# 國家運輸安全調查委員會

華信航空股份有限公司 AE7931 班機

報告編號：TTSB-AOR-20-09-001

## 附錄 1 法國 ATR(BEA)對調查報告草案之回復意見及運安會決議

圖 2.2-1 客艙高度與相關資料繪圖

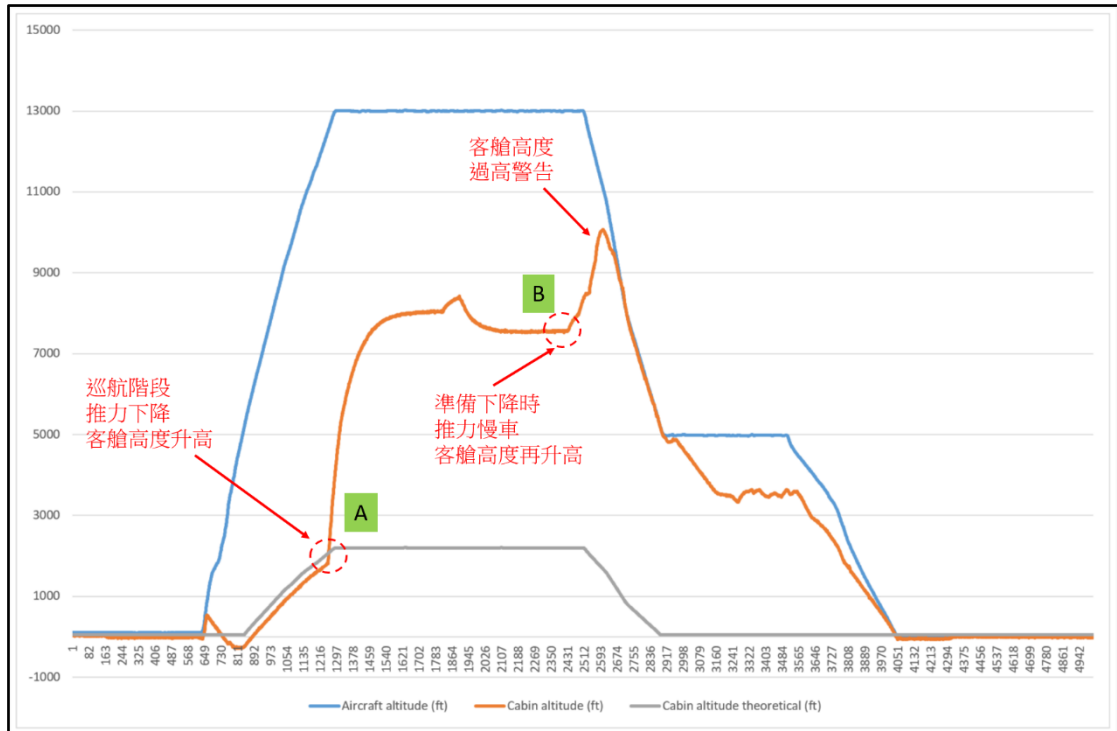
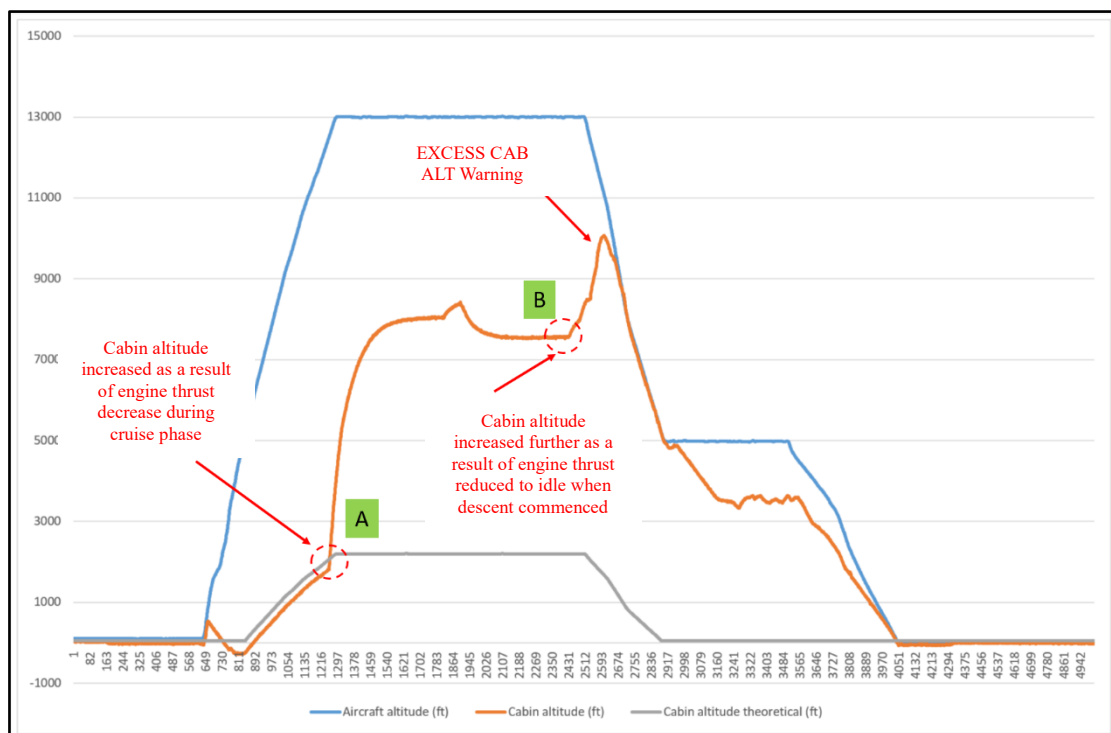
<p>4</p>	<p>Page 27 2.2.1</p>	<p>When the occurrence aircraft reached cruising altitude (13,000ft), the thrust of the engine decreased, and so did the airflow in the air-conditioning system, resulting in the rise of cabin altitude (after Point A in Figure 2.2-1), but it was maintained at approximately 8,000ft.</p>	<p>When the occurrence aircraft reached cruising altitude (13,000ft), there is a sudden rise of cabin altitude (after Point A in Figure 2.2-1) probably due to the collapse of the air-conditioning distribution tube downstream the valve, which increases the external leakage, not compensated by the air conditioning system. The cabin altitude was finally maintained at approximately 8,000ft.</p>	<p>The decrease of engine thrust cannot alone explain the increase of the cabin altitude, as the engine thrust in cruise condition is still sufficient to maintain the required regulated pressure and flow supplied to the cabin.</p>

<p>5</p>	<p>PAGE 27 2.2.1</p>	<p>Cabin altitude increased as a result of engine thrust decrease during cruise phase</p>	<p>Cabin altitude increased as a probable result of the collapse of the air-conditioning distribution tube downstream the valve.</p>	<p>The decrease of engine thrust cannot alone explain the increase of the cabin altitude, as the engine thrust in cruise condition is still sufficient to maintain the required regulated pressure and flow supplied to the cabin.</p>

2.2.1	事故機到達巡航高度（13,000 呎）後，發動機推力下降同時使空調系統進氣量下降，導致航機客艙高度上升（圖 2.2-1A 點以後），惟仍控制在約 8,000 呎；	When the occurrence aircraft reached cruising altitude (13,000ft), there is a sudden rise of cabin altitude (after Point A in Figure 2.2-1) probably due to the collapse of the air-conditioning distribution tube downstream the valve, which increases the external leakage, not compensated by the air conditioning system. The cabin altitude was finally maintained at approximately 8,000ft.	Not accept The air-conditioning distribution tube downstream the valve, though distorted, did not break, therefore, the external leakage would not be increased. The draft report will not be changed.
